**GARVEY COMMONS/ SHERBURNE HALL**  
ADDITIONS & REMODELING  
ST. CLOUD STATE UNIVERSITY  
ST. CLOUD MINNESOTA

REVISED	PROJECT NO. 86015
	ISSUE DATE 12-15-66
	DRAWN BY FEW
	CHECKED HV
	APPROVED ARCHITECT FW
	SCALE AS SHOWN

**SITE PLAN**

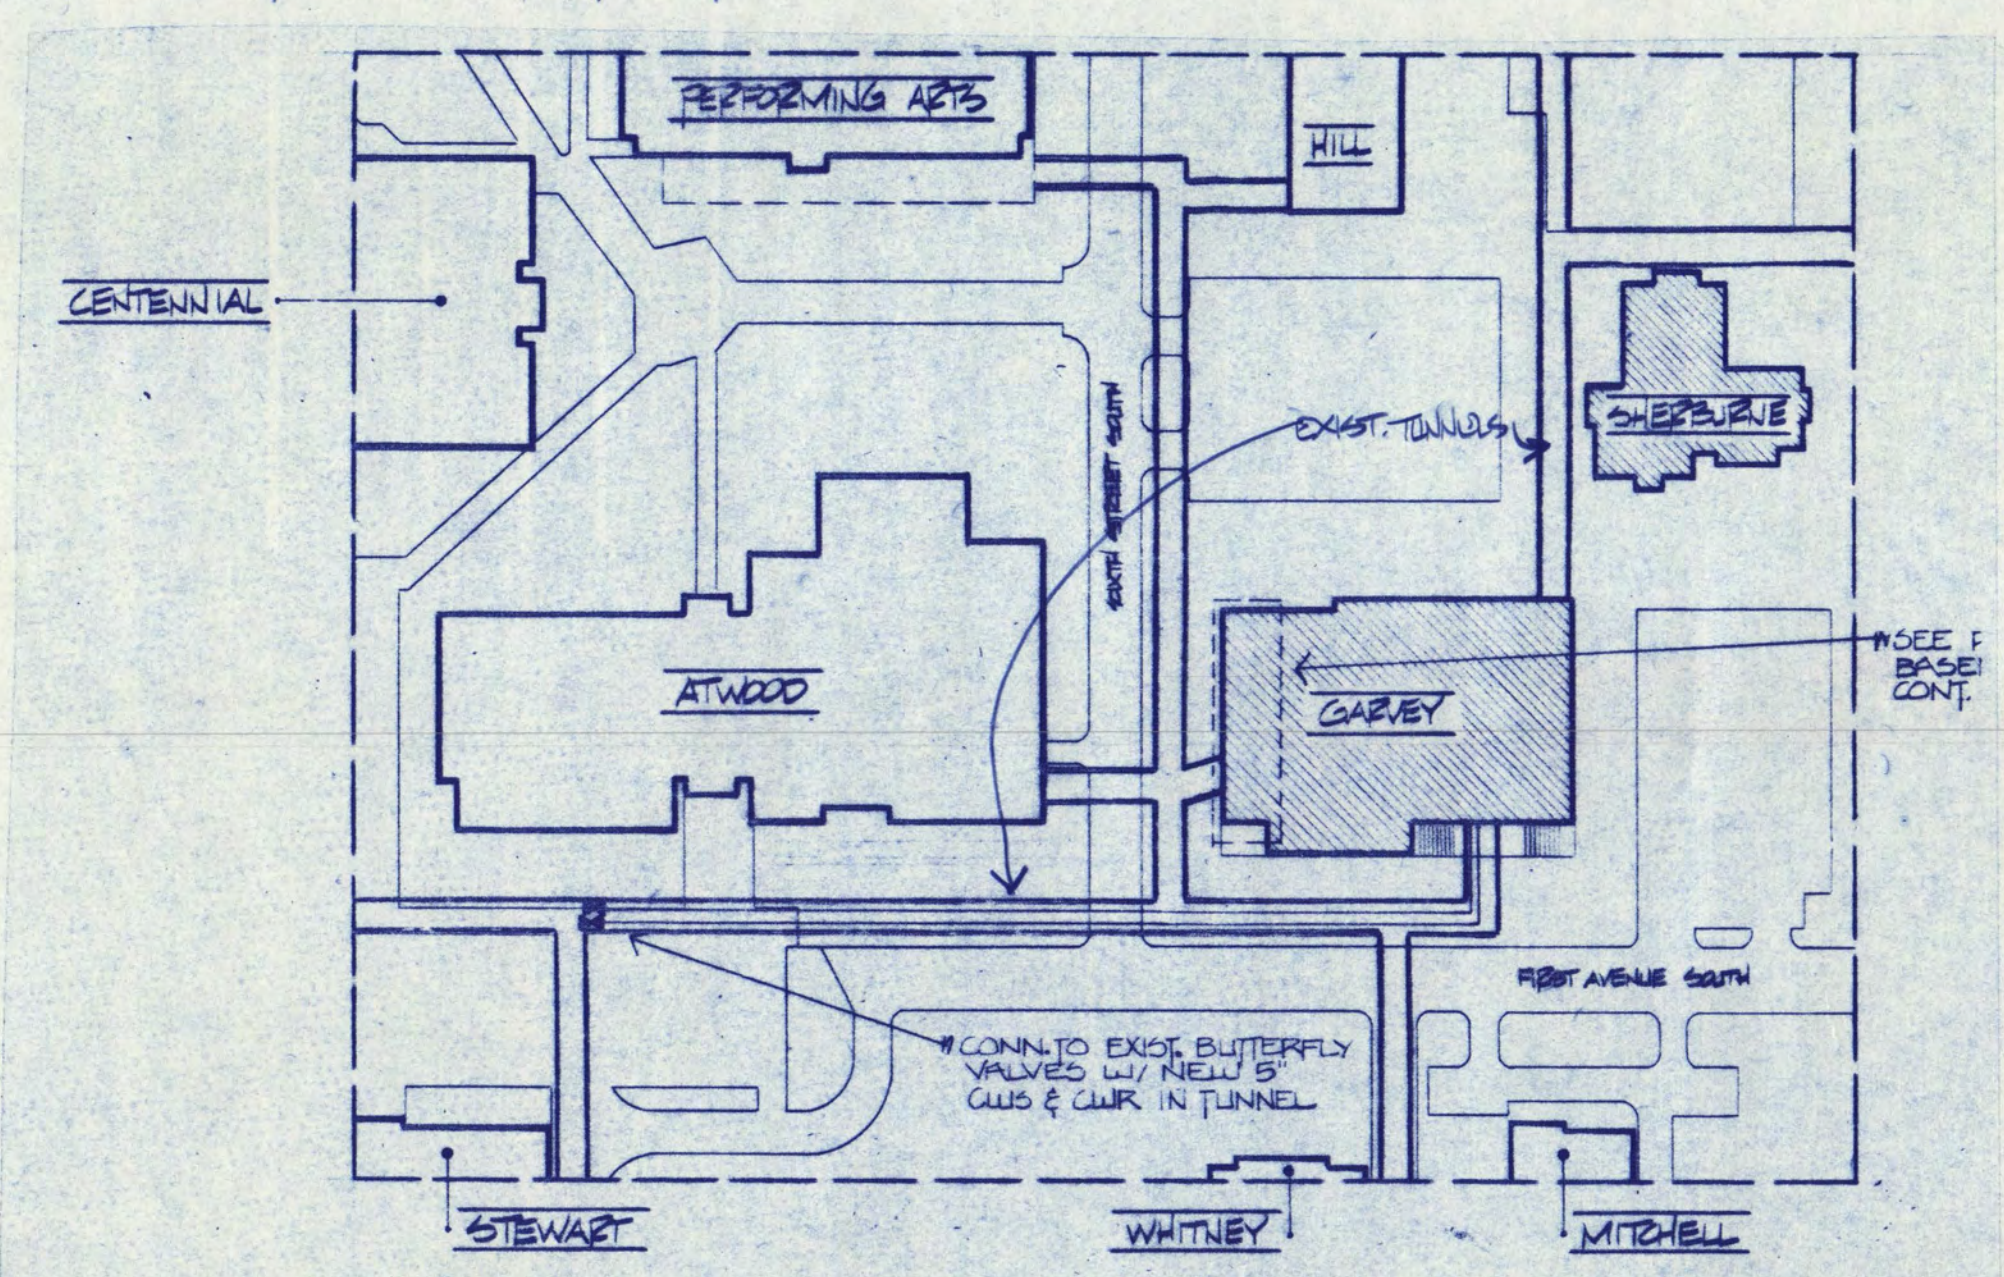
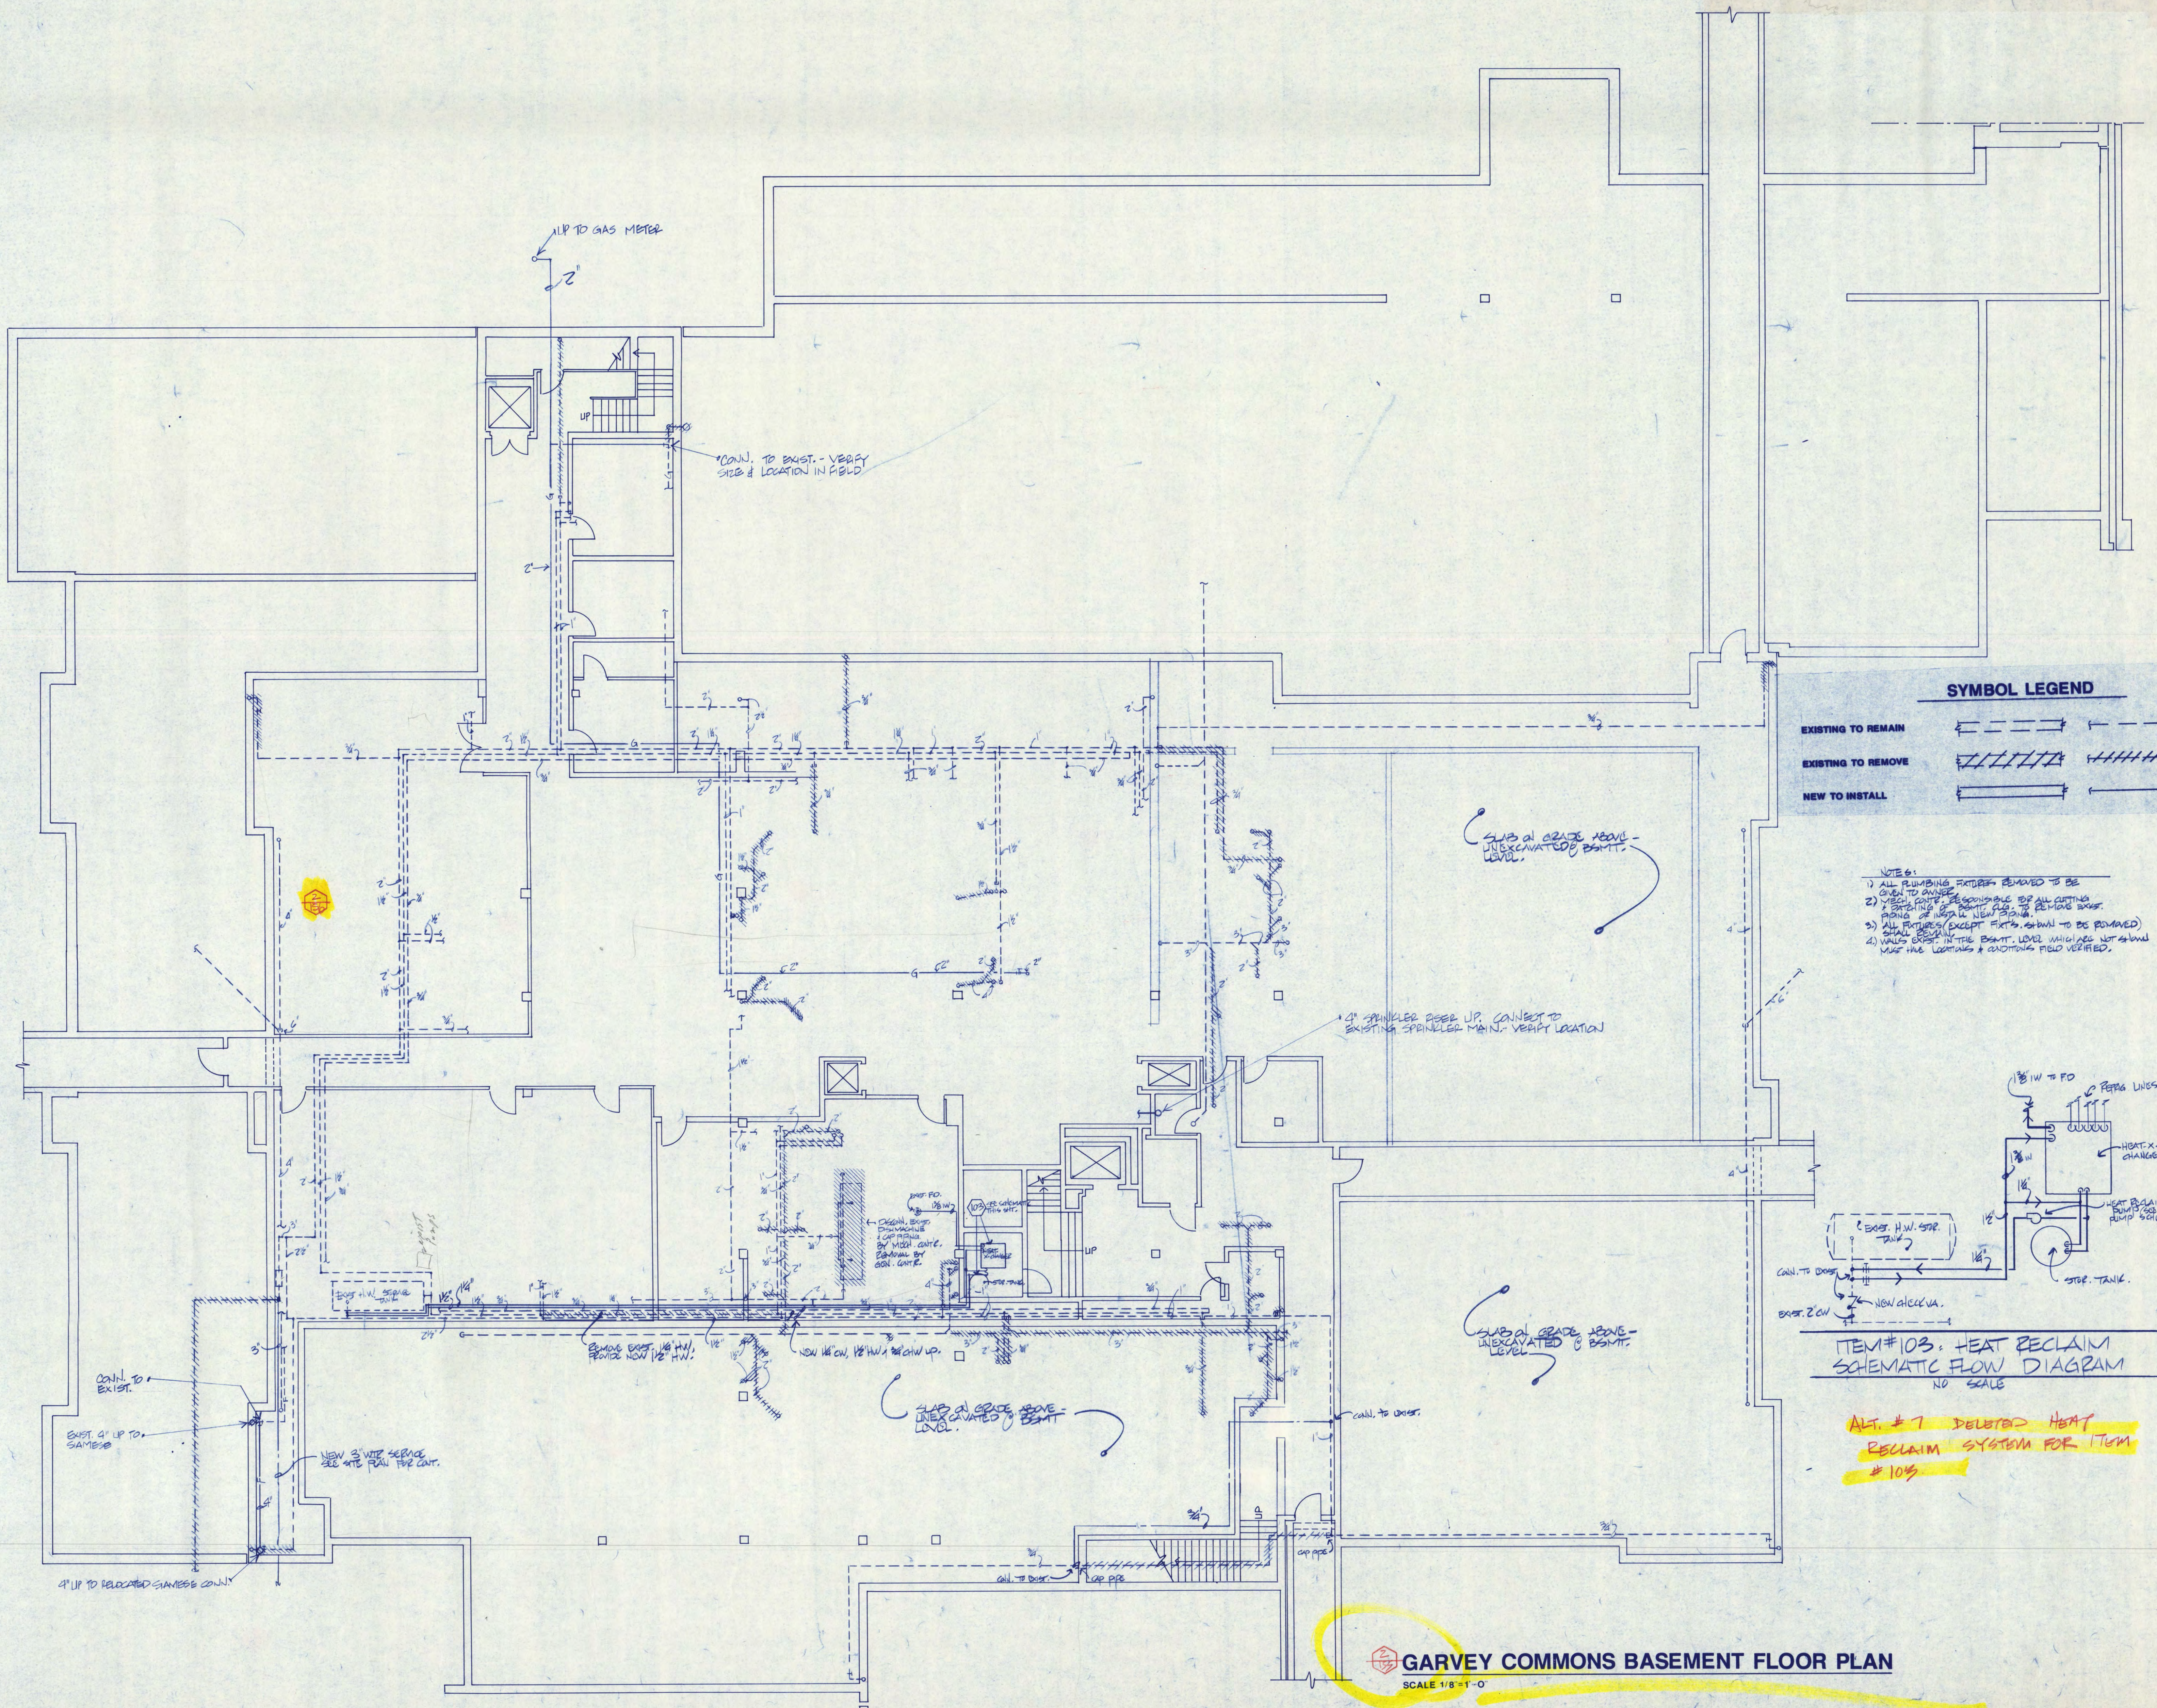
- 152. Relocating gas meter shall be the responsibility of the mechanical contractor.
- 153. Underground sanitary sewer from M.H. EX-1 to M.H.-2 shall be cast iron. Underground sanitary sewer from M.H.-2 to M.H.-3 shall be cast iron.
- 154. A. Replace existing 6" sanitary sewer from Garvey Building to M.H. EX-1 with new 6" cast iron.  
B. New 6" cast iron shall extend into existing Garvey Building (replacing existing 5") approximately 20'. The new 6" cast iron below basement floor shall extend up to and include new 6" x 4" x 4" wye fitting.

- 155. This drawing shall be further identified as Plumbing and Fire Protection - Demolition and Remodel.
- 156. Replace existing 4" back water valve located near the southwest corner in the basement floor. Josam 1110 series.

**ITEM#103: HEAT RECLAIM SCHEMATIC FLOW DIAGRAM**  
NO SCALE

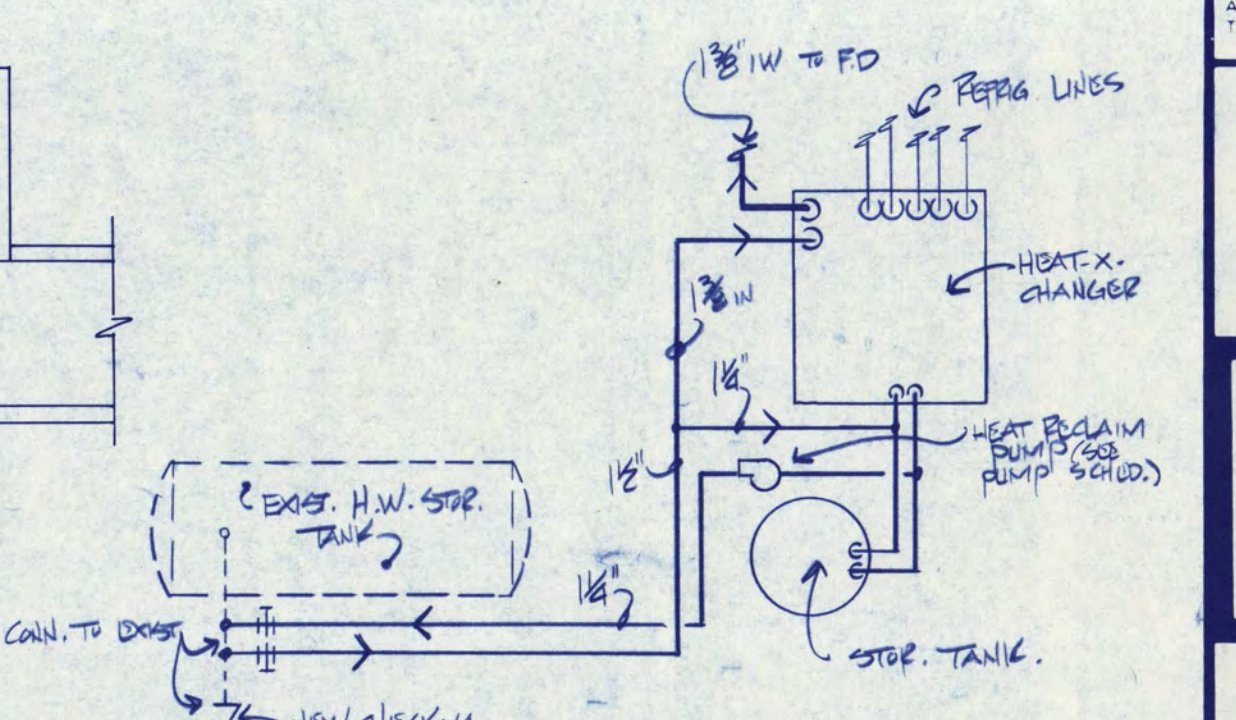
**ALT. # 7 DELETED HEAT RECLAIM SYSTEM FOR ITEM # 103**

**GARVEY COMMONS BASEMENT FLOOR PLAN**  
SCALE 1/8" = 1'-0"

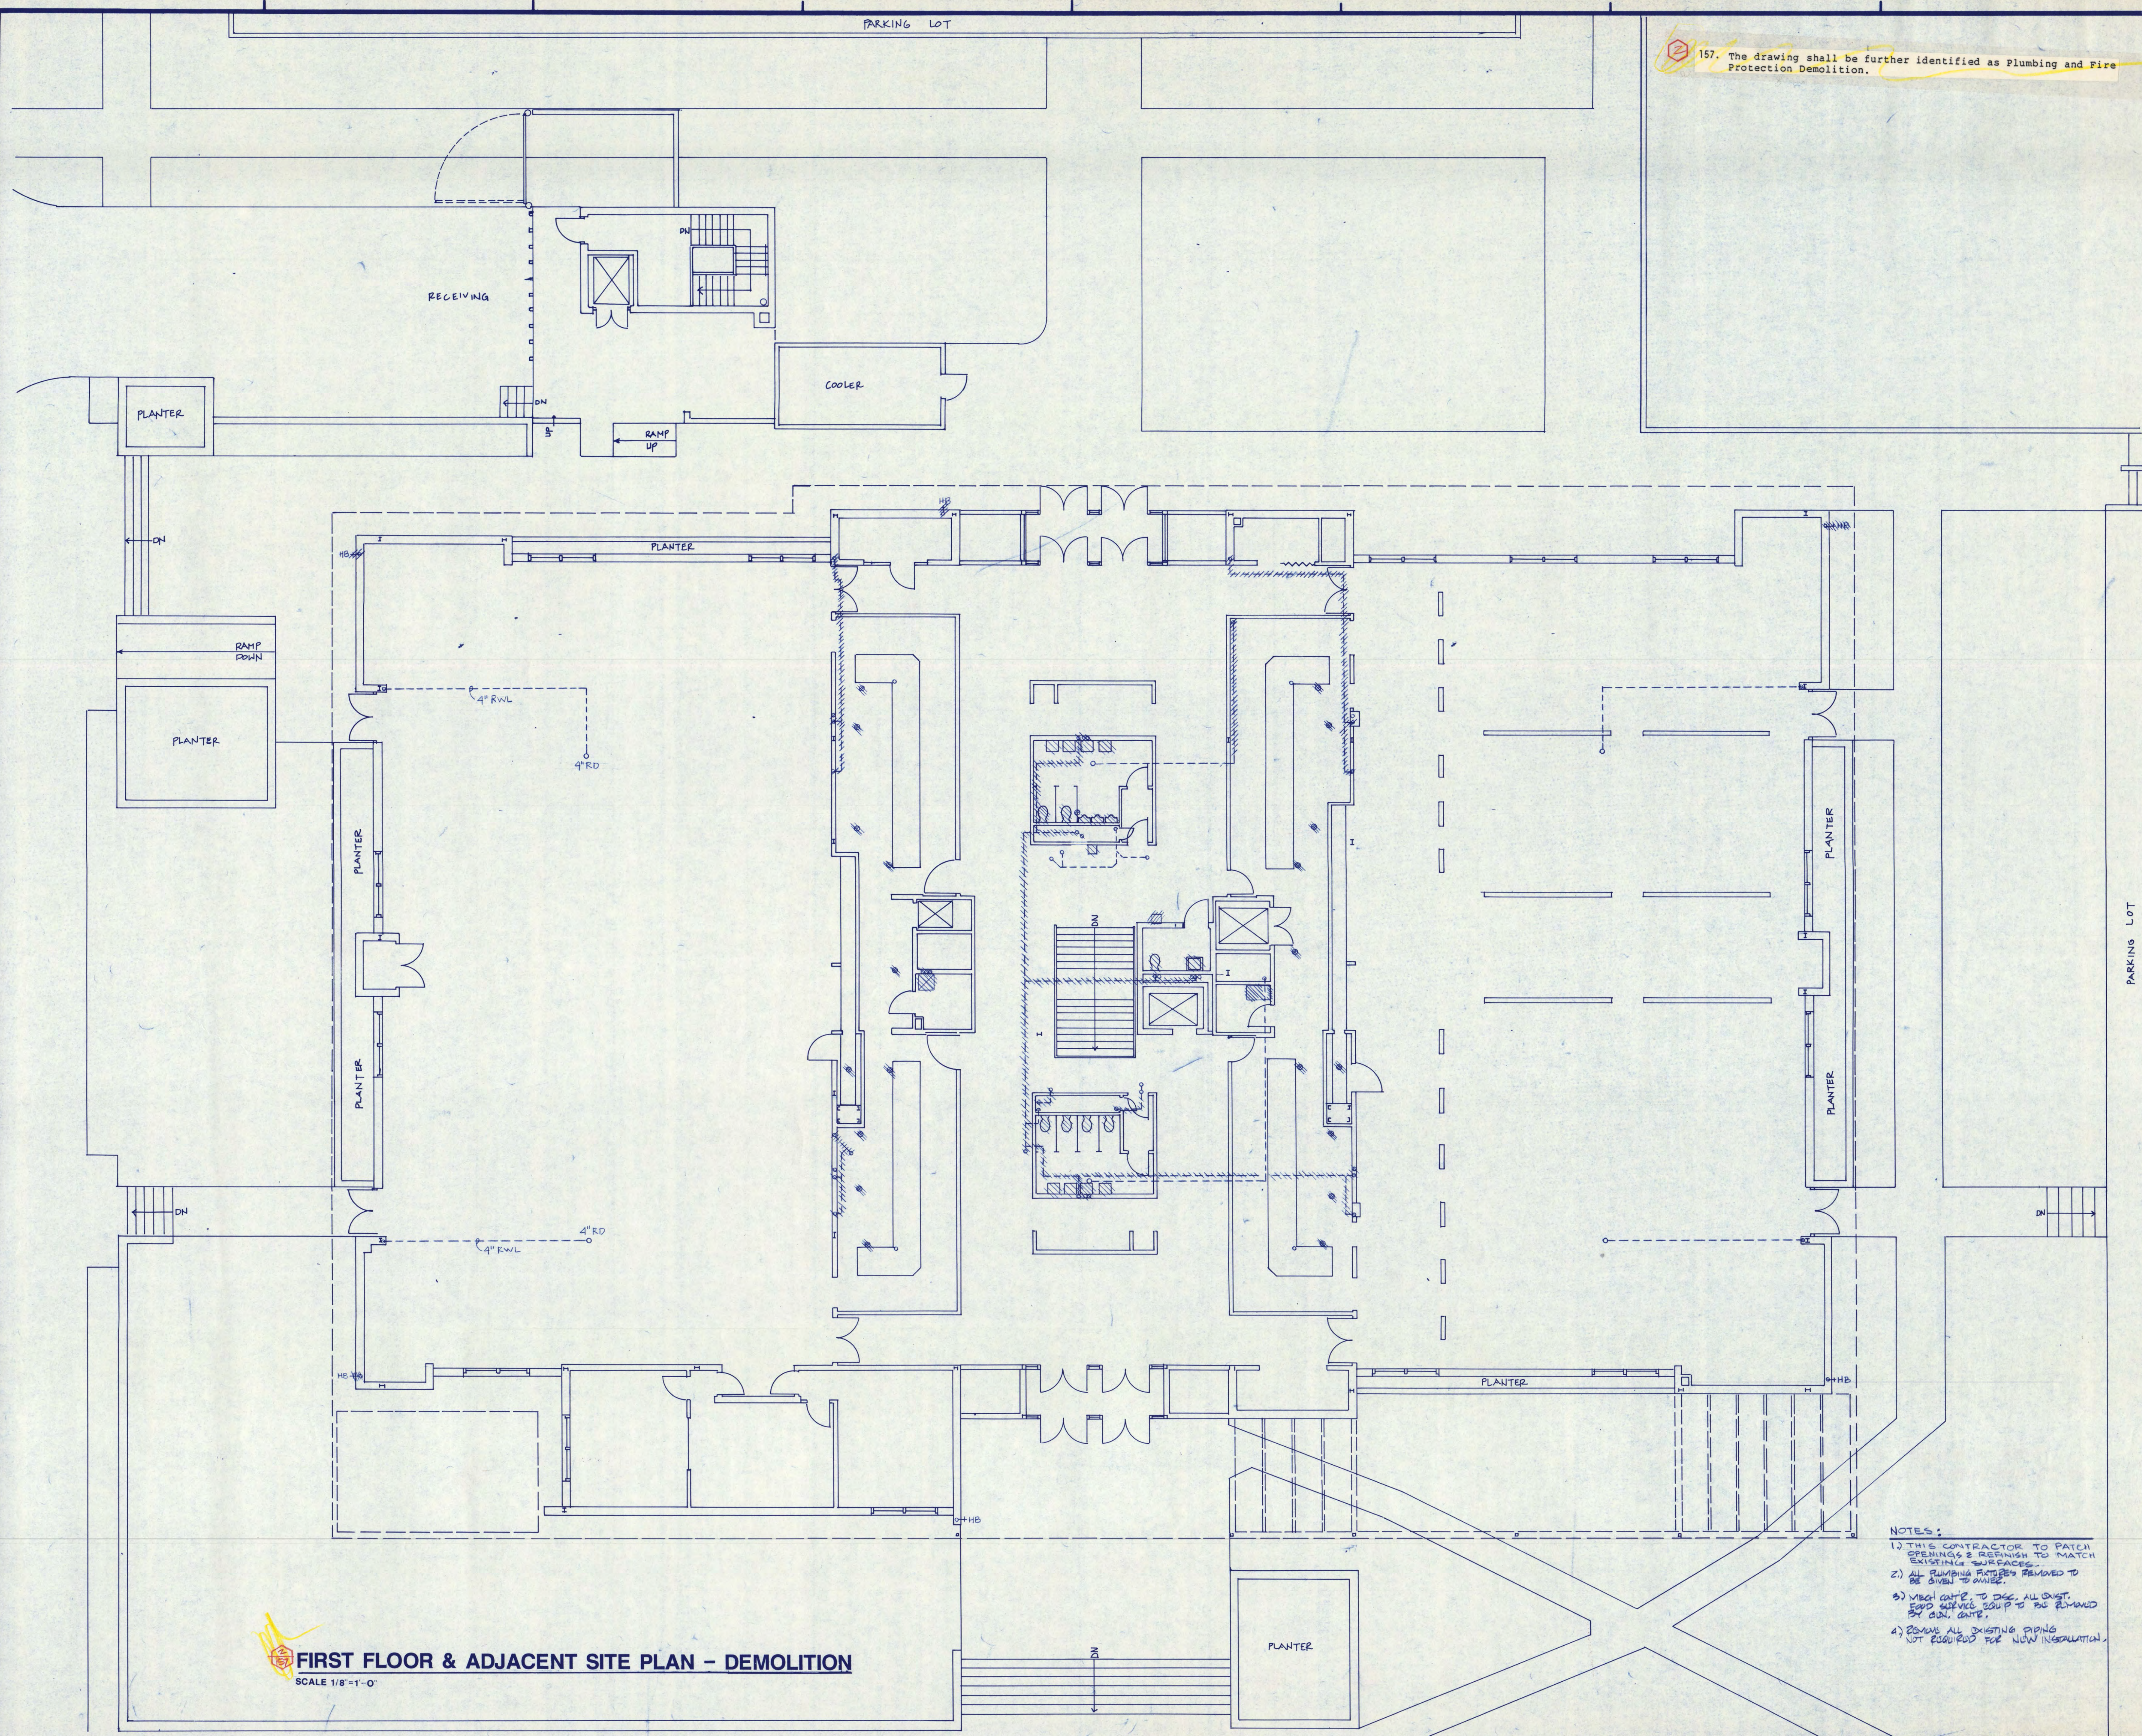
157. The drawing shall be further identified as Plumbing and Fire Protection Demolition.
